DEVELOPMENT APPLICATION ASSESSMENT REPORT

Application Number:	DA2021/0556
----------------------------	-------------

Responsible Officer:	Jordan Davies
Land to be developed (Address):	Lot 104 DP 752046, 39 Attunga Road NEWPORT NSW 2106
Proposed Development:	Demolition works and construction of a dwelling house, including swimming pool and garage
Zoning:	E4 Environmental Living SP2 Infrastructure
Development Permissible:	Yes - Zone SP2 Infrastructure Yes - Zone E4 Environmental Living
Existing Use Rights:	No
Consent Authority:	Northern Beaches Council
Land and Environment Court Action:	No
Owner:	Lance Robert Horton
Applicant:	Lance Robert Horton

Figure 1 - Extent of non-compliance at south-western corner caused by butterfly roof form eave. Central non-compliance removed from proposal.

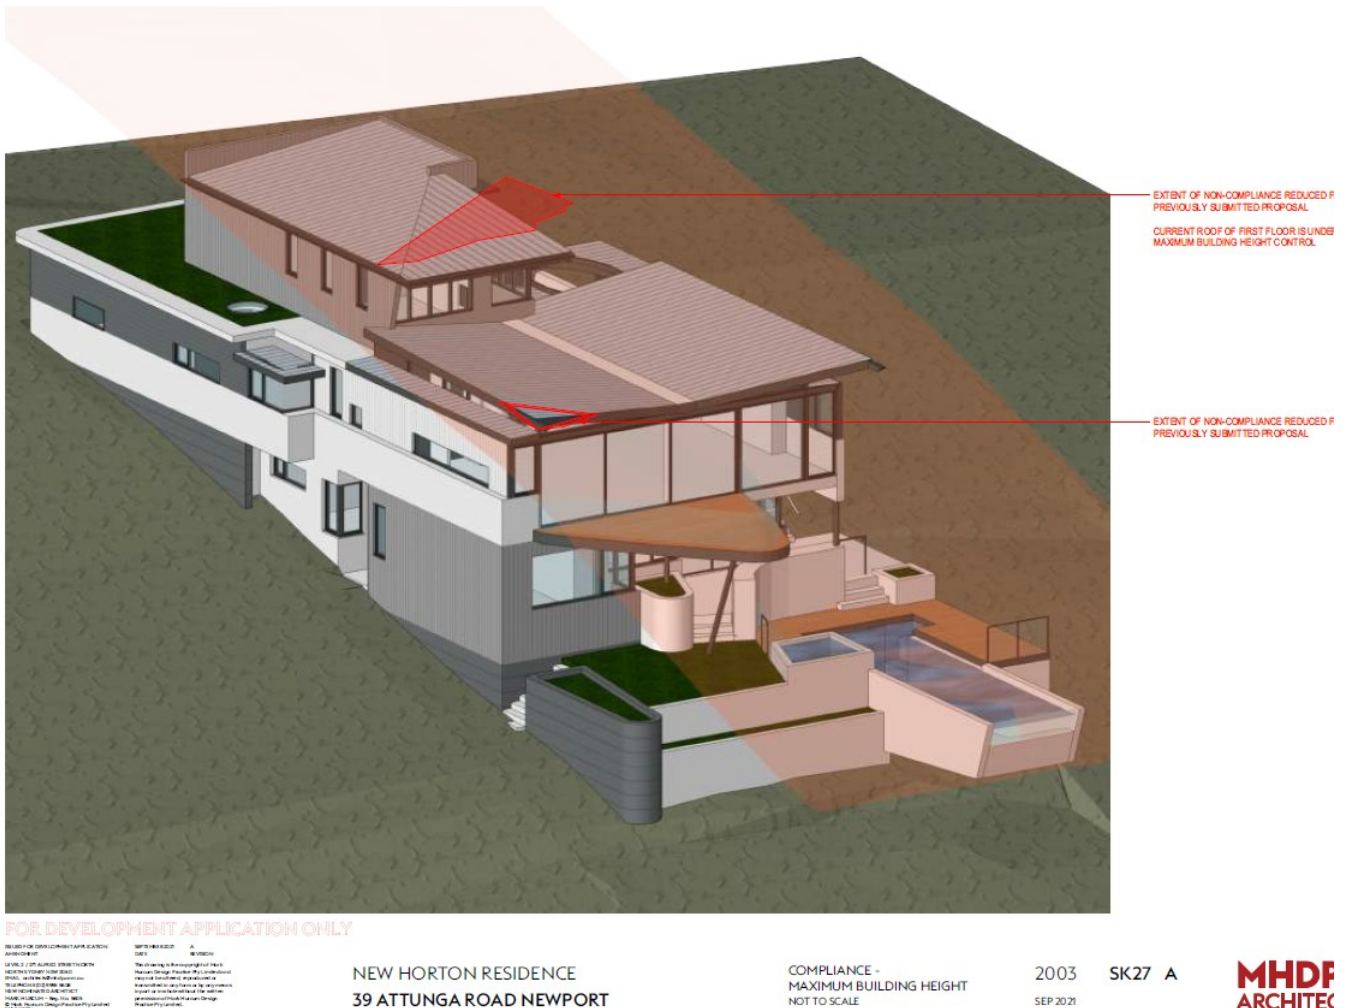
Development standard:	Height of buildings
Requirement:	8.5m
Proposed:	8.85m
Percentage variation to requirement:	4.1%

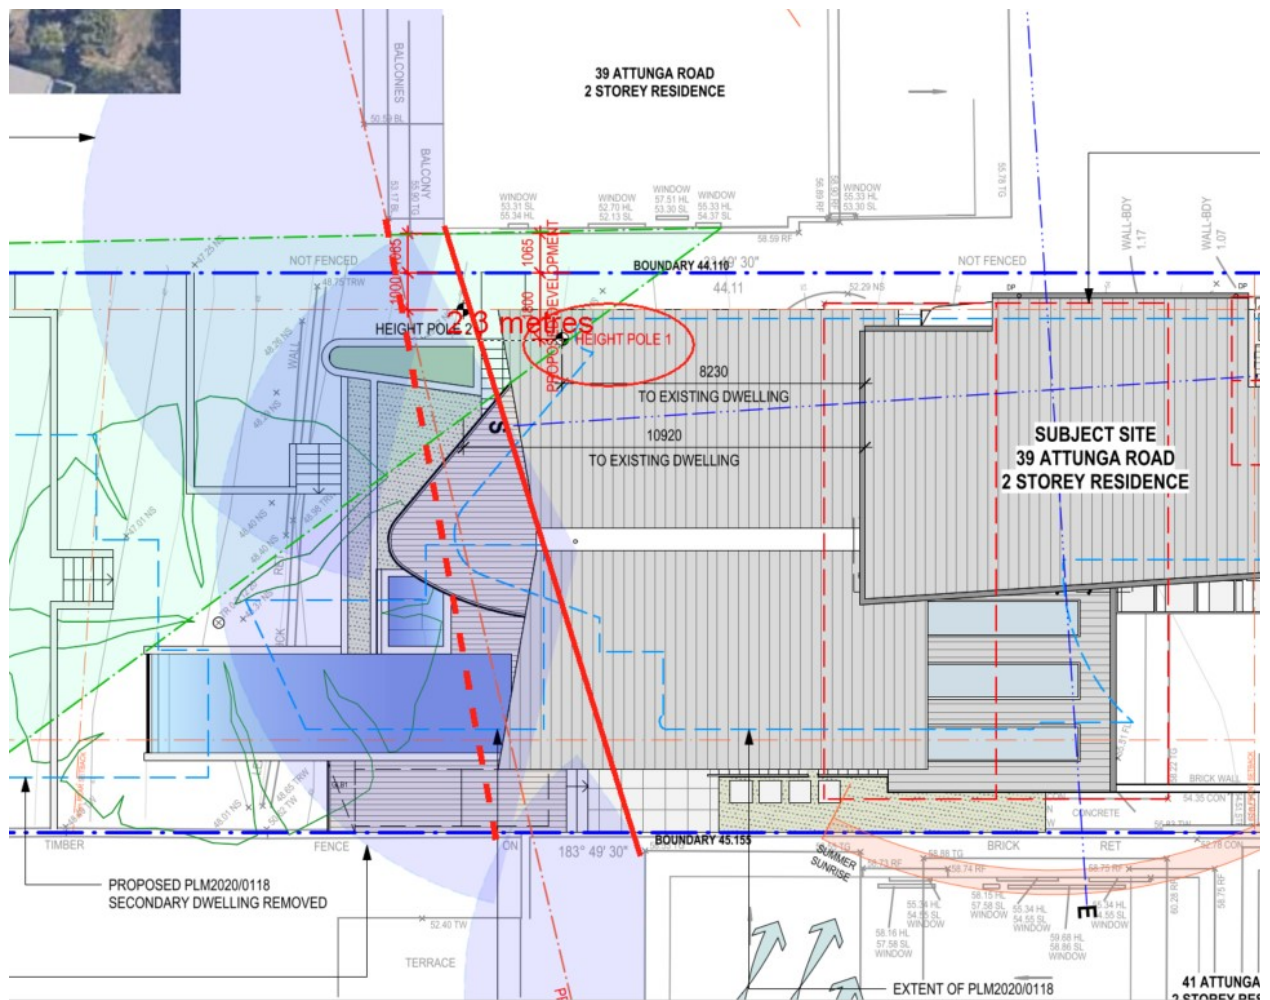
The proposed development does present a non-compliance with the western building envelope control and a minor breach of building height (350mm). However, these two controls do not give rise to direct view impacts resulting from the development. Rather, it is the southern alignment of the proposal with the two neighbouring properties (37 Attunga and 31 Attunga) which influence the view corridor to be impacted. The below figure demonstrates that the south-western corner of the building facade is in alignment with the predominant building line of the adjoining buildings and therefore, is considered to have a reasonable setback to the southern boundary. Furthermore, the south-western facade is setback 2.3m behind this building alignment and is well behind the predominant building line set by the two adjoining building facades. Given the facade of the building is consistent with the alignment of the adjoining buildings, the view impact over the side boundary resulting from the south-western corner of the building is considered to be reasonable and entirely consistent with how the site could reasonably be developed given the alignment of the adjoining buildings.

As south-western corner of the building is setback behind this alignment and further increase to the setback is not considered warranted, given the substantial views that are maintained looking south from the living room, dining room, kitchen and balcony from the dwelling at 37 Attunga Road. The south-western corner of the building being setback 2.3m behind the building line shows the design is skillfully designed to provide for a reasonable view corridor, even through this is over a side boundary.

The proposed balcony has a minor protrusion of the of established building line, however, this balcony has a glass balustrade and is centrally located within the property which still allows a view corridor to be maintained through to the south-east. The balcony is also designed with splay to allow a view corridor through to the south-east, demonstrating skillful design.

Figure 1 - Elevation shadow diagrams submitted with application.

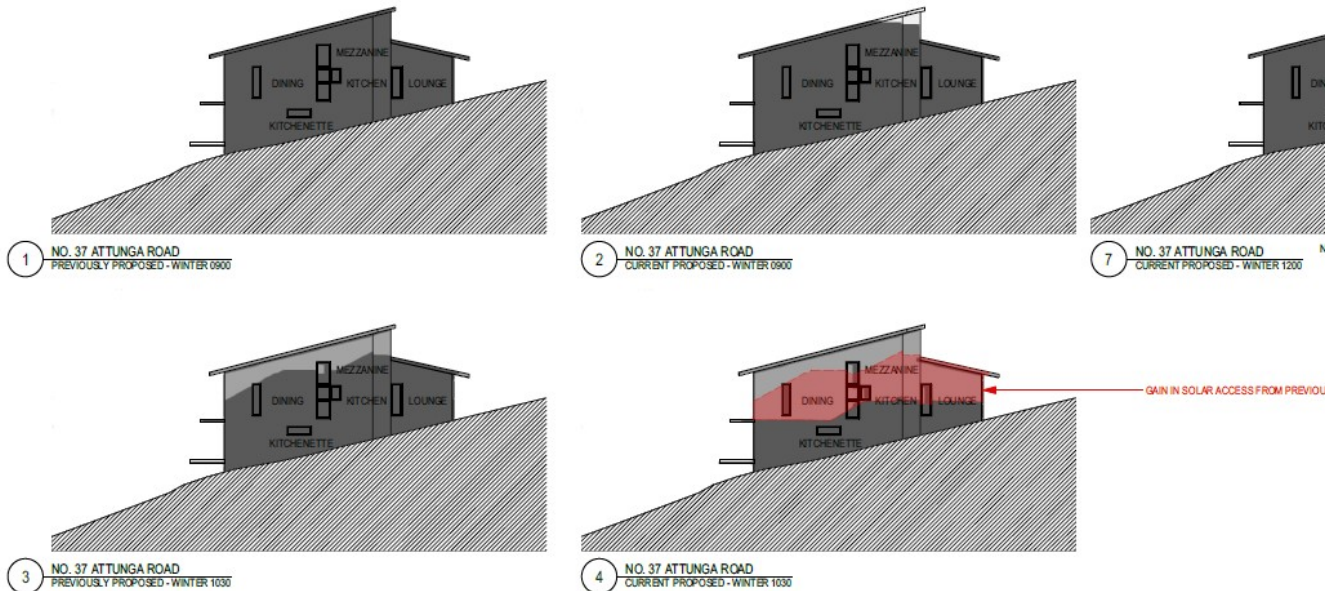
The eastern facade of the dwelling at 37 Attunga Road has a dining room window, as labelled on the

submitted elevation shadow diagram in Figure 1 below. There has been a submission raised regarding impact to this window and more generally the windows on the eastern elevation. The dining room window also services the living room at the southern western extent 37 Attunga Road and therefore this window is addressed below with regards to the control requiring 3 hours to the principle living area. The assessment is also made in response to the building envelope encroachment to the western side and the 350mm building height non-compliance at the south-western butterfly roof form.

The original plans submitted with the application resulted in a larger impact to the dining room window as a result of the first floor master bedroom configuration (comparison of impact shown in Figure 1 above). To improve solar access to the dining room window, the plans were amended to increase the setback to the master bedroom from the western boundary by an additional 2.3m, resulting in improved solar access to the dining room window which will receive 50% solar access by 10:20am (figure 2). Figure 2 shows that sunlight does not hit the dining room window until 9:41am in either a fully complying scheme or the proposed scheme. Therefore, a full 3 hours of solar access directly to the east facing dining room window is not possible in either a complying scheme or the proposed scheme, with solar access to the dining room window available at 10:20am in both scenarios (figure 3).

Figure 2 - Sun view diagram 9:41am, no sunlight received in either scenarios prior to this time.

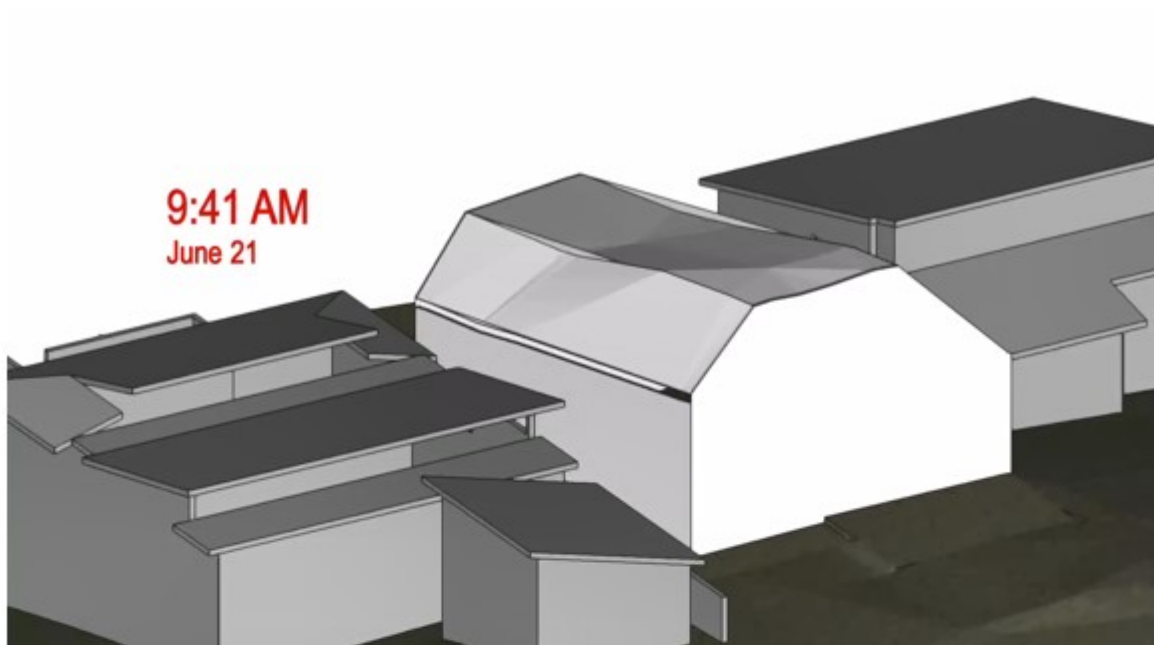
However, it must be considered in the assessment that the eastern facing dining room window does not provide solar access to the main living area and dining room in isolation. The solar access provided by the north facing clerestory window must be taken into account in the assessment, with this window providing sunlight through to the living room as well. This clerestory window will continue to receive solar access throughout the day and when combined with the solar access received to the east facing window by 10:20am, will provide the minimum required 3 hours.

Figure 3 - Sun view diagram, solar access to dining room window received by 10:20am.

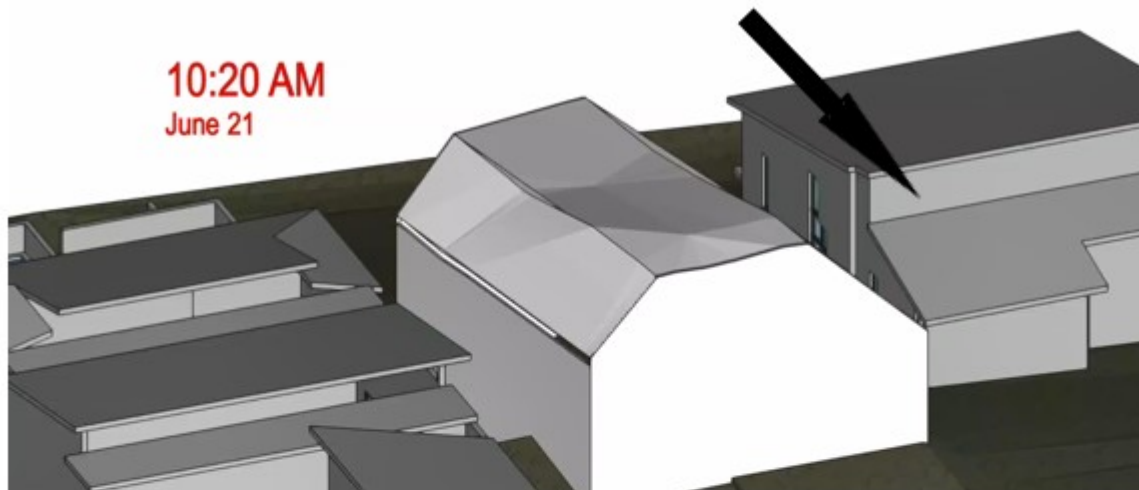
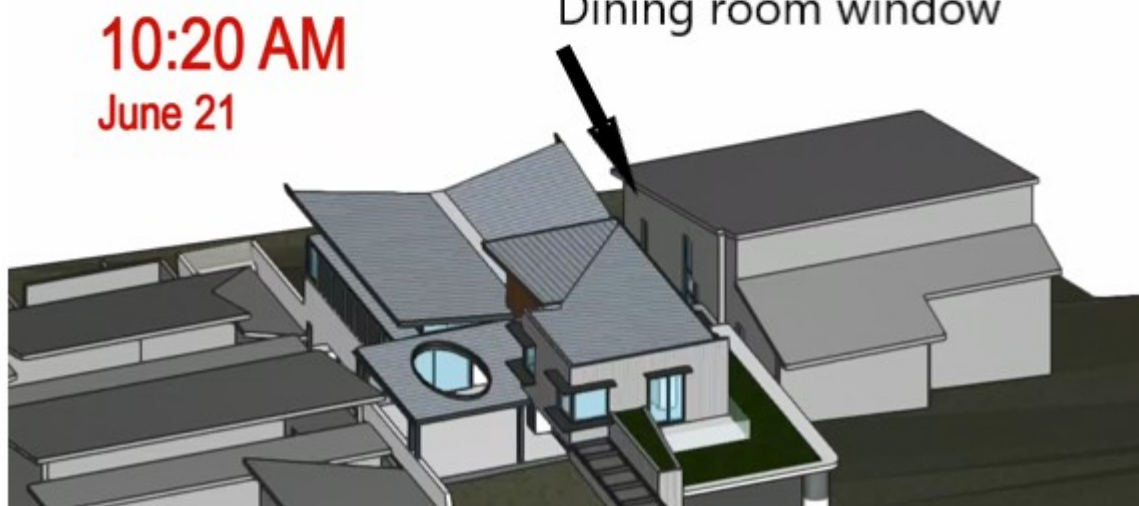
In regards to the building height breach at the south-western corner of the butterfly roof form, as seen in Figure 2 and 3 this element of the building does not result in additional impact to the eastern facing windows when compared to a fully compliant scheme. In this regard, the building height breach does not cause an unreasonable solar access impact.

In regards to the building envelope breach, the applicant's amended scheme which moved the master bedroom and additional 2.3m west reduced the extent of non-compliance and improved solar access, compared to the original plans. When compared to a fully compliant scheme, the envelope breach results in some additional overshadowing between 9:41am and 10:20am (39 minutes) to the eastern facing dining room window. However, the solar access to the living room/dining room via the eastern facing window cannot be looked at in isolation as the north facing clerestory window will continue to receive full solar access during this time, with the combination of both windows resulting in the minimum 3 hours solar access. Therefore, the 39 minute loss in solar access to the eastern facing

dining room window is acceptable, when considering the overall solar amenity received by all windows which provide sunlight to the living area of 37 Attunga Road, with sunlight continuing to be received via the north facing clerestory window and in combination with the solar access received post 10:20am to the eastern facing window.

Figure 1 - Extent of eastern envelope encroachment shown in dark red.

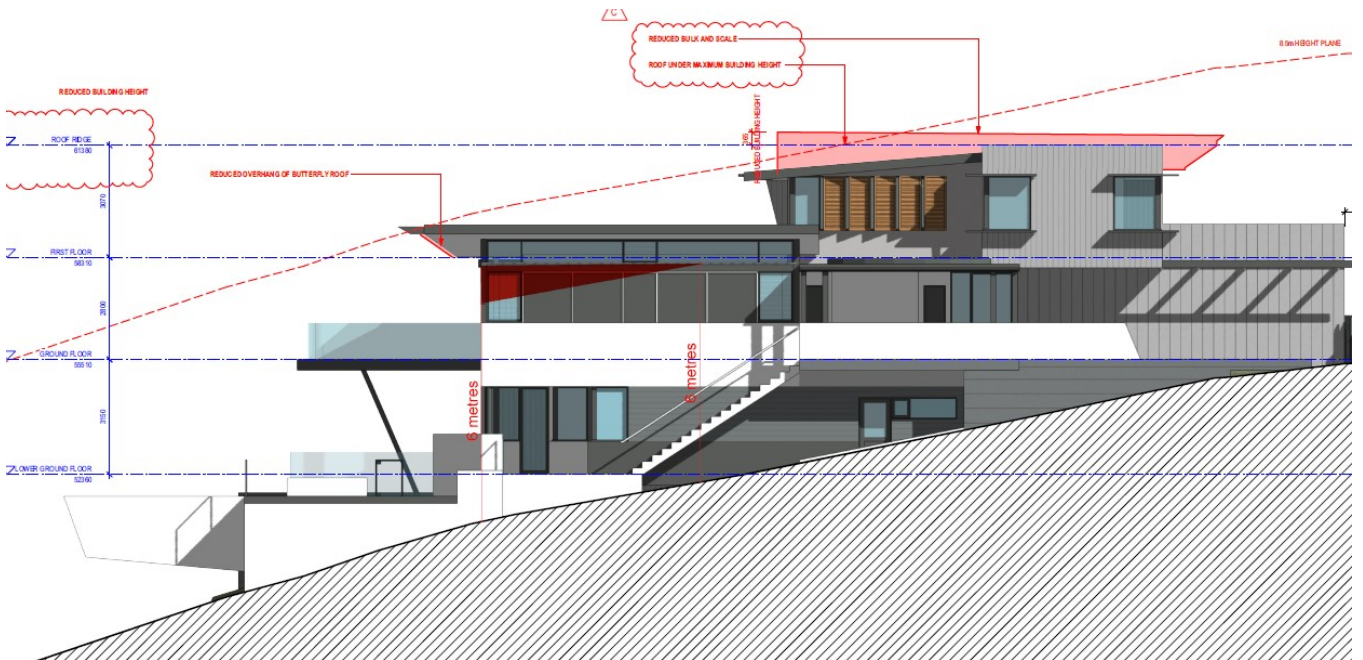
The DCP contains a variation clause which permits encroachment of the envelope on a site with a slope of 16.7 degrees or more. The subject site has a slope of 14 degrees and does not technically meet this requirement, however, Council may still consider a variation to the control on merit.

The extent of envelope breach is shown in the below figures for the western and eastern boundary. It is noted that the original plans submitted with the applicant had a much more substantial breach of the building envelope caused by the upper level master bedroom. Amended plans were received which shifted this element away from the western boundary to increase compliance and improve solar access. Furthermore, the extent of the butterfly roof form at the southern end of the building was reduced, with the roof form lowered and the eave projection reduced.
